NOTIFICATION OF TRANSMITTAL OF
INTERNATIONAL PRELIMINARY
EXAMINATION REPORT

PCT/US03/05300

INTERNATIONAL PRELIMINARY EXAMINATION REPORT

Light sensitive
Display

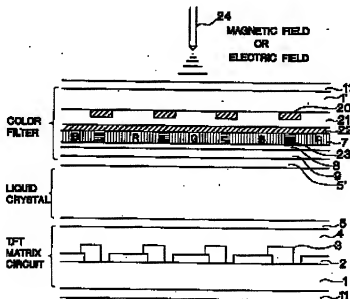
Claims 10, 11, 16, 18 and 23 lack novelty under PCT Article 33(2) as being anticipated by Kim, USPAT 5,568,292.

Kim discloses and shows in Fig. 5, an active matrix light sensitive display comprising:

(a) a light valve including a front polarizing element (11), a rear polarizing element (11), and a liquid crystal material (applicant's light rotating material) located between the front polarizing element and the rear polarizing element; and

(b) a plurality of thin film transistors (3) (applicant's light sensitive elements) located between either the front polarizing element or the rear polarizing element and the light rotating material. Accordingly, claims 10, 11 and 23 are anticipated.

As to claim 16, Kim also shows in Fig. 5 that the display also comprising:

Accordingly, claim 16 is anticipated.

Fig. 3

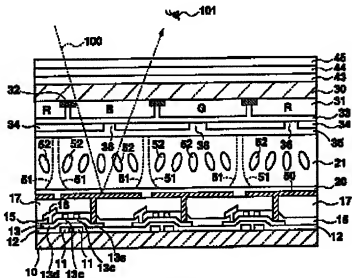
Claims 27-29 lack novelty under PCT Article 33(2) as being anticipated by Noritake et al., (Noritake), US 2001/0046013.

reflective display electrode (50) and counter electrode (34);

liquid crystal material (20); and

a plurality of TFT (applicant's light sensitive elements) located within the

display wherein the display selectively causing the pixels to provide a bright

and uniform image (bright and uniform image is obtained by causing the pixels to provide light).

Accordingly, claims 27-29 are anticipated.

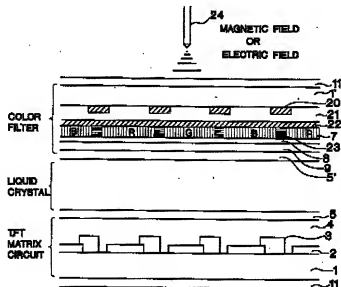
Claims 10, 11, 16, 18 and 23 lack novelty under PCT Article 33(2) as being anticipated by Kim, USPAT 5,568,292.

Kim discloses and shows in Fig. 5, an active matrix light sensitive display comprising:

(a) a light valve including a front polarizing element (11), a rear polarizing element (11), and a liquid crystal material (applicant's light rotating material) located between the front polarizing element and the rear polarizing element; and

(b) a plurality of thin film transistors (3) (applicant's light sensitive elements)

located between either the front polarizing element or the rear polarizing element and the light rotating material. Accordingly, claims 10, 11 and 23 are anticipated.

As to claim 16, Kim also shows in Fig. 5 that the display also comprising: a transparent counter electrode layer (9) (applicant's front electrode layer), a transparent picture element electrode (2) (applicant's rear electrode layer), and a liquid crystal material (applicant's light rotating material) located between the front electrode layer and the rear electrode layer wherein the front electrode layer and the rear electrode layer defining a plurality of pixels within the light rotating material.

Accordingly, claim 16 is anticipated.

As to claim 18, Kim also shows in Fig. 5 that the plurality of light sensitive elements (3) are located at least partially between the pixels, with respect to a perpendicular direction to the front of the display.

Fig. 3

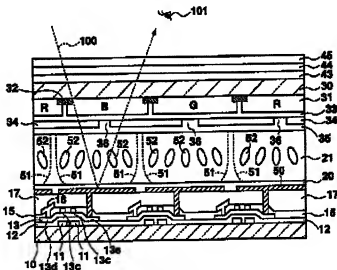
Claims 27-29 lack novelty under PCT Article 33(2) as being anticipated by Noritake et al., (Noritake), US 2001/0046013.

Noritake discloses (page 2, paragraph 0032-0035) and shows in Fig. 3, a light sensitive active matrix liquid crystal display comprising:

reflective display electrode (50) and counter electrode (34);

liquid crystal material (20); and

a plurality of TFT (applicant's light sensitive elements) located within the

display wherein the display selectively causing the pixels to provide a bright

and uniform image (bright and uniform image is obtained by causing the pixels to provide light).

Accordingly, claims 27-29 are anticipated.
